BEACON PLANNING BOARD
Via Video-Conference
BEACON, NEW YORK 12508
Phone (845) 838-5002 Fax (845) 838-5026

Beacon Views - Conklin Street

Continue public hearing for SEQRA environmental review on applications for Subdivision and Site Plan Approval, "Beacon Views Townhouses" 40 units, Conklin Street, submitted by Beacon Views, LLC

RE: Beacon Views Site Plan and Conservation Subdivision
Conklin Street
Beacon, New York
Tax Parcel ID: 6055-03-331123

DELIVERY TRUCK MANEUVER 1
SCALE : 1" = 60'

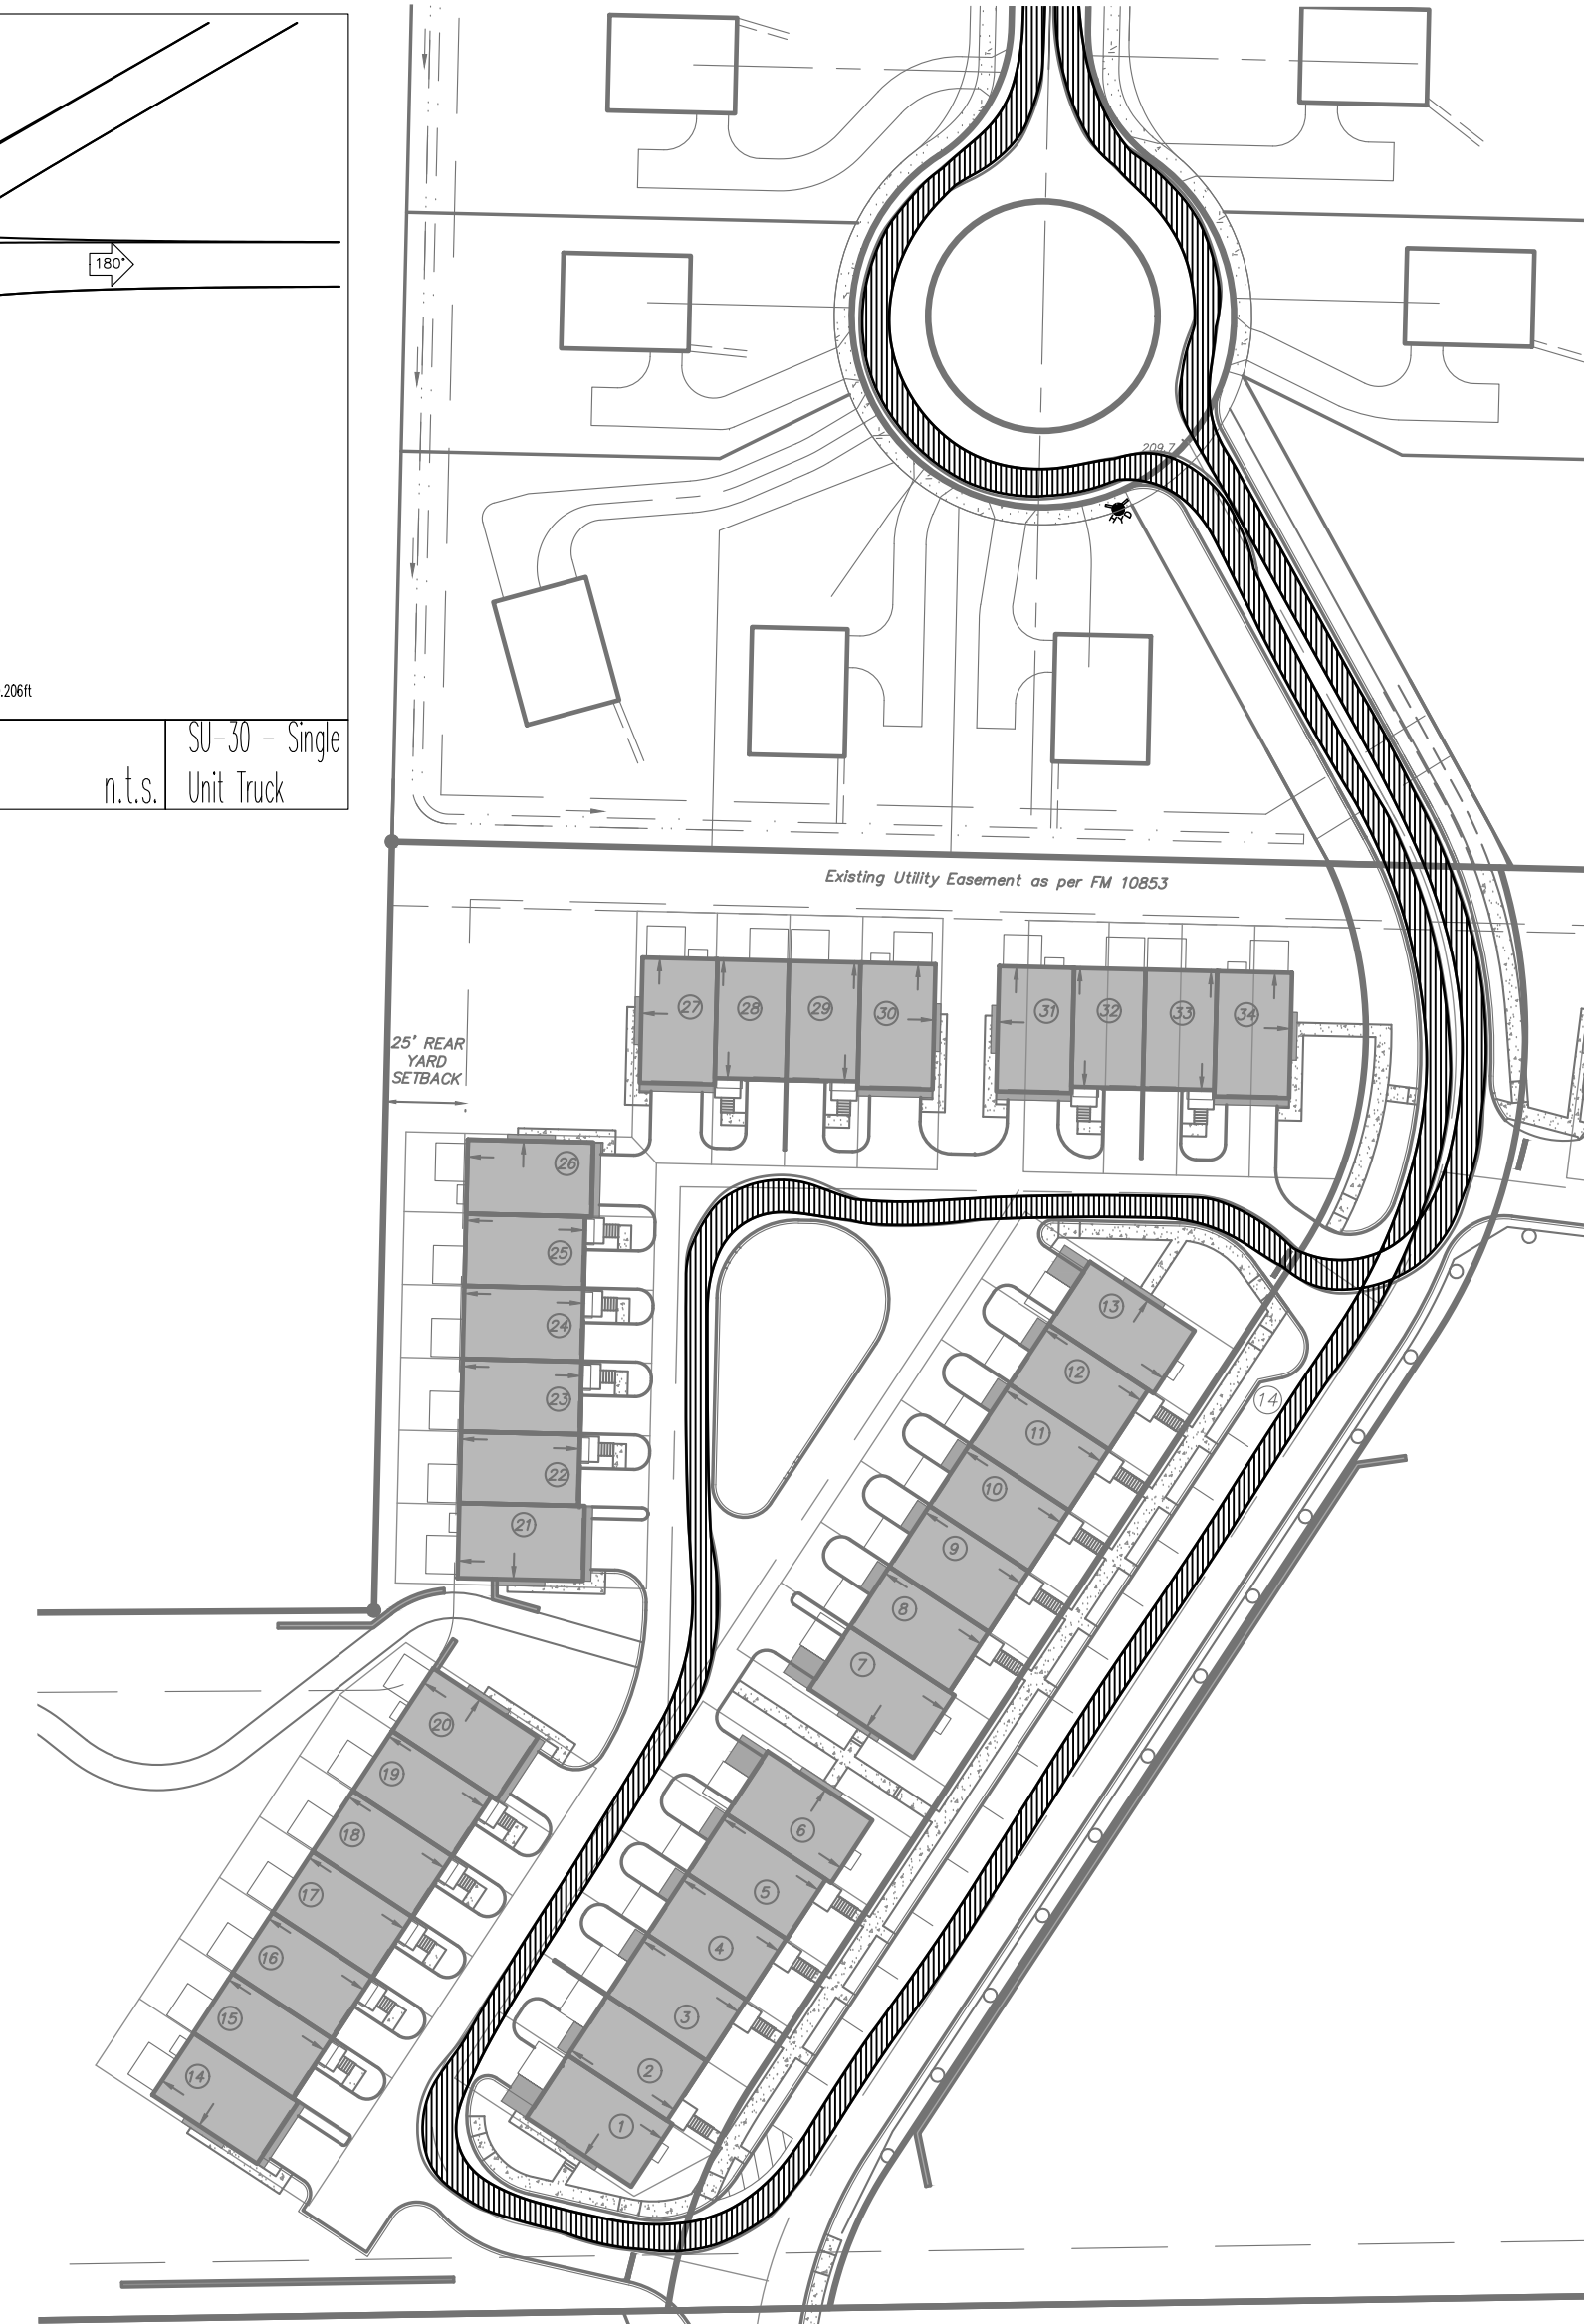
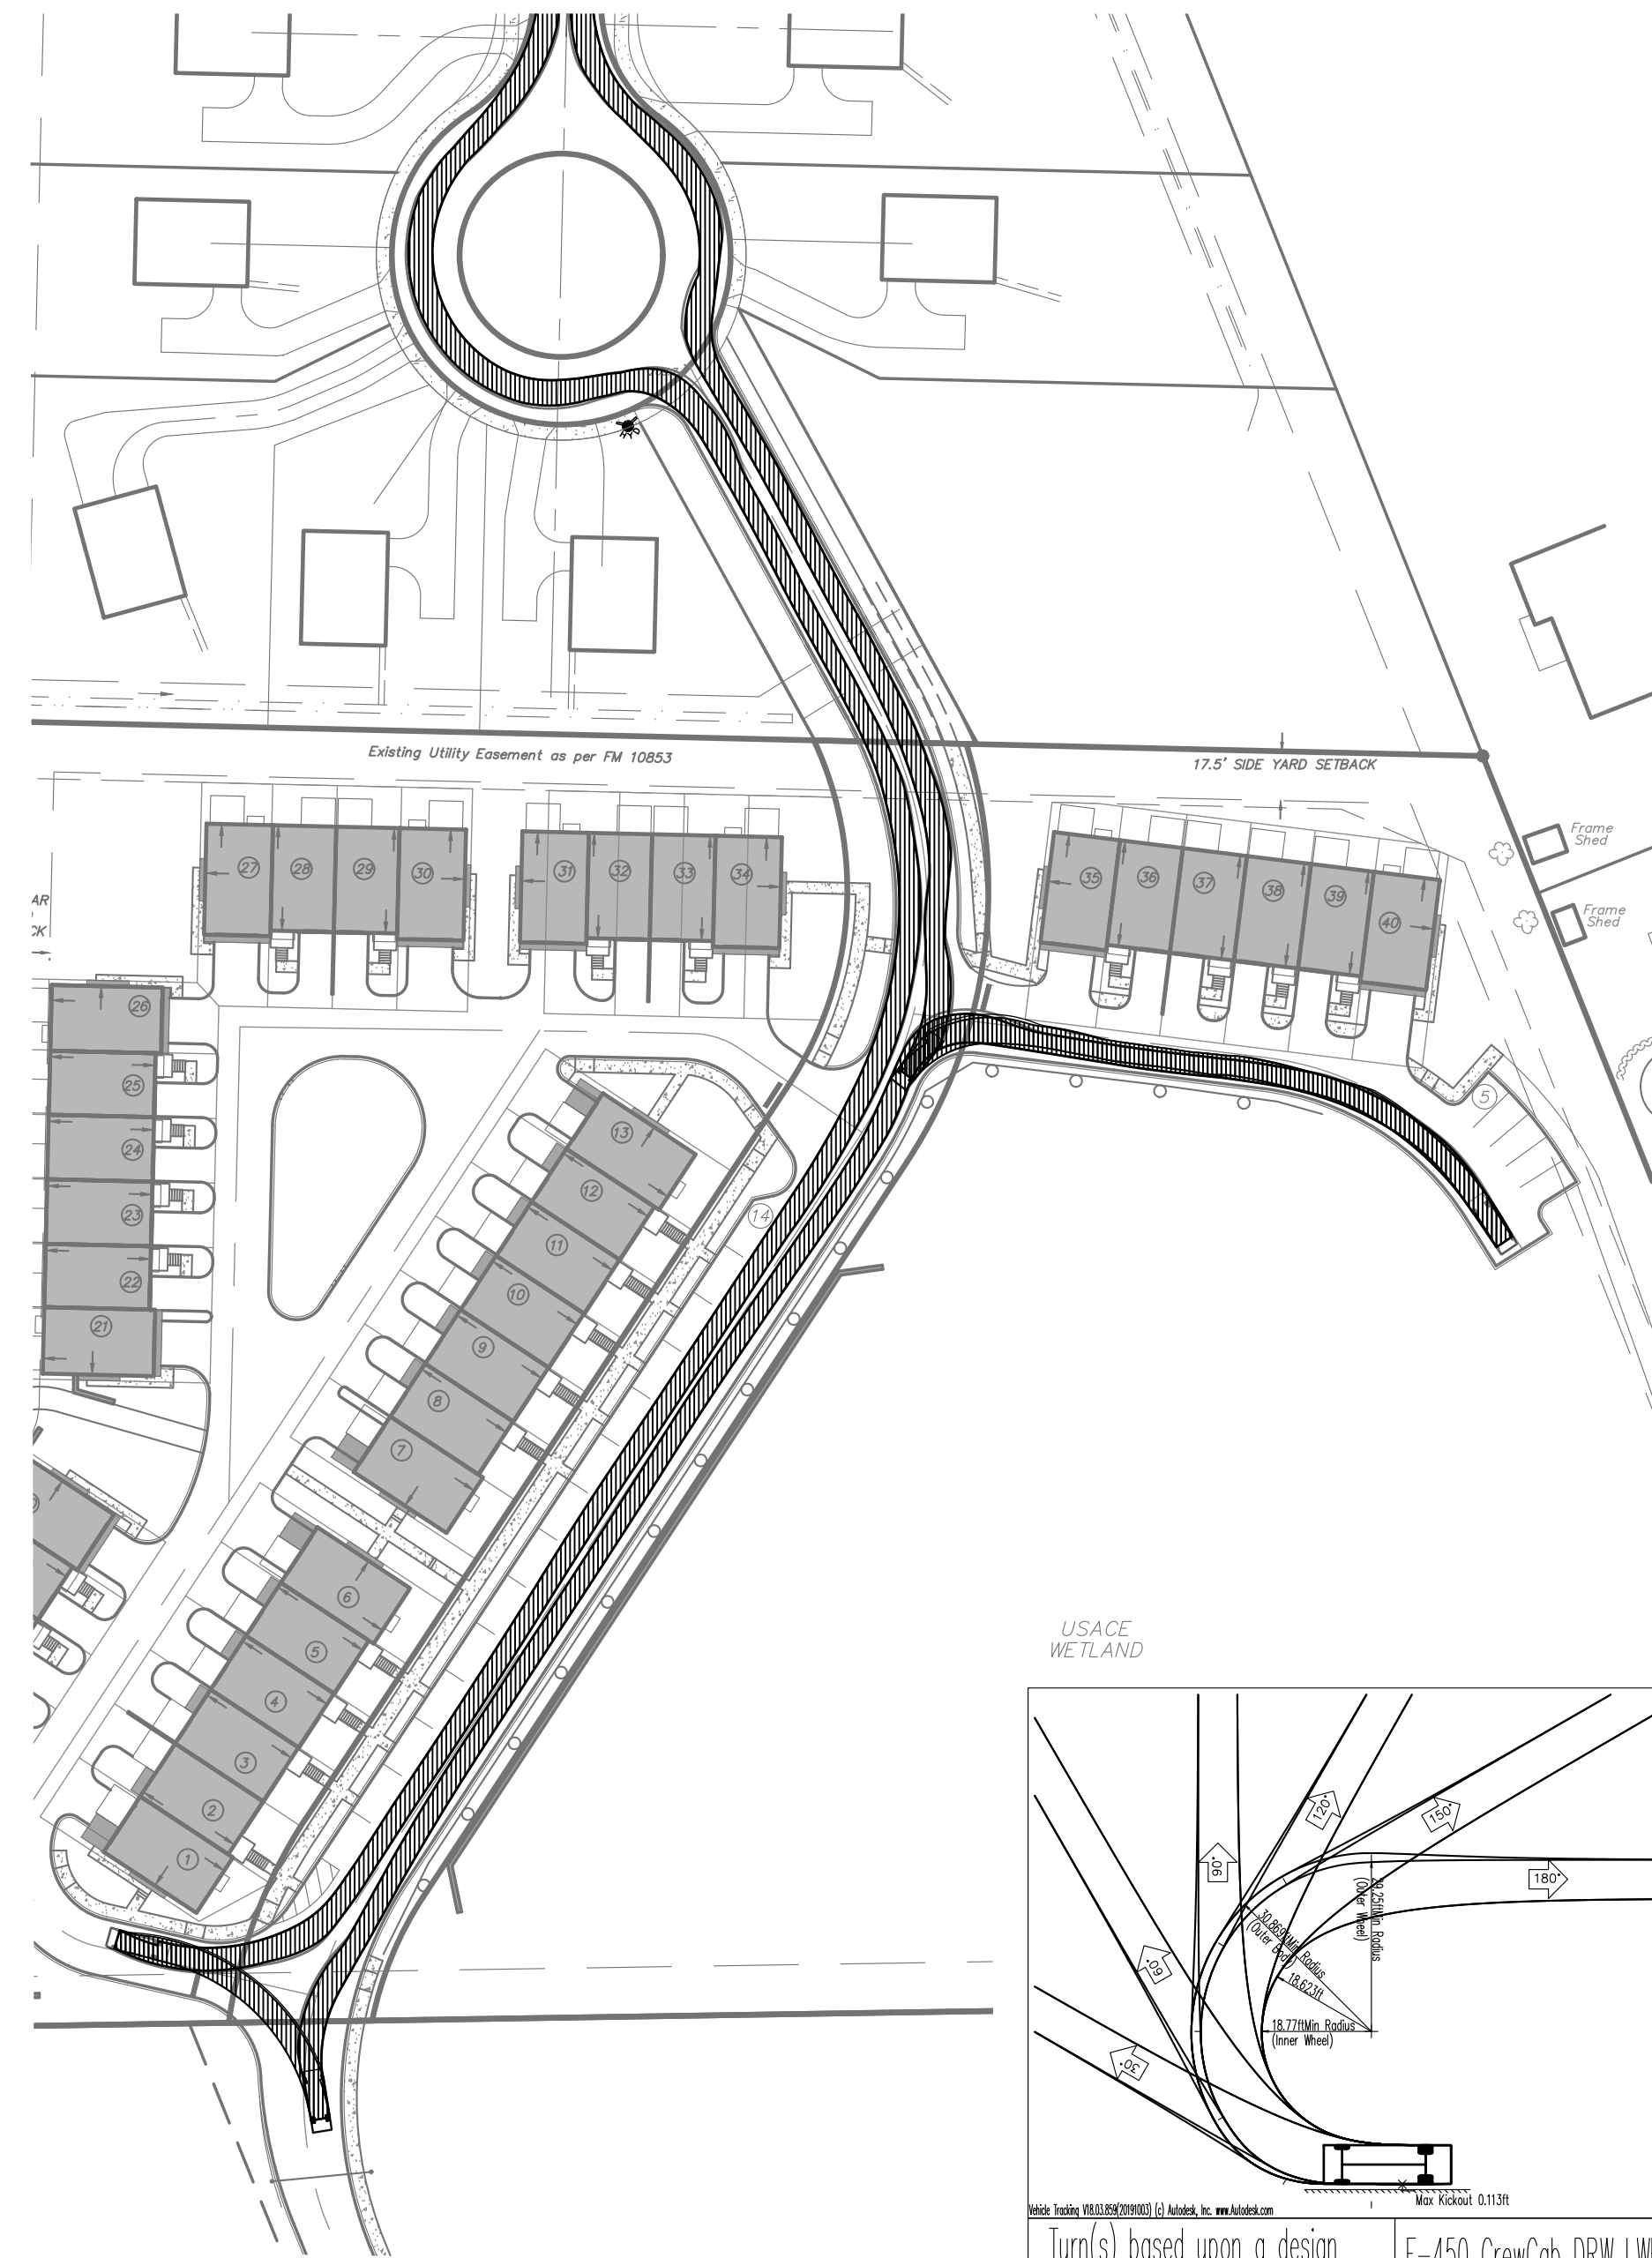
1. The details for the vehicles have been enlarged for legibility.
2. The road alignment, sidewalk layout, proposed grades, utilities, and proposed drainage modifications have been shown entering and running the extent of the pending City right of way on the 25 Townsend Street property. It is the applicant's understanding that the realignment of the 25 Townsend Street road, and how that road would connect to the right of way, including the potential elimination of the cul-de-sac, is the obligation of the owners of 25 Townsend Street.
